Clutch Pedal Squeak/Creak Noise

Service Category Drivetrain

Section Clutch

The information contained in this bulletin supersedes SB No. TC004-06.

Figure 1.

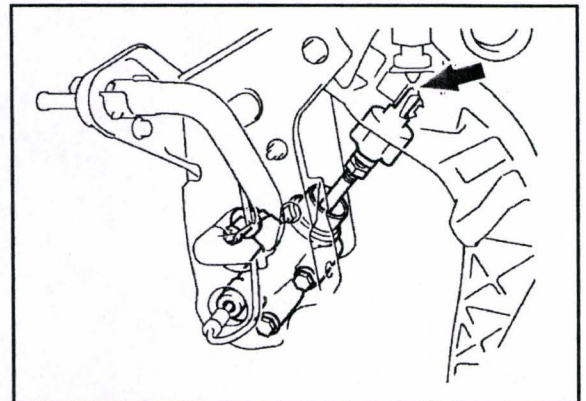
Be sure to apply MP Grease where the clutch master cylinder clevis and clutch pedal meet in addition to the locations identified in the Repair Manual (See Figure 1.)
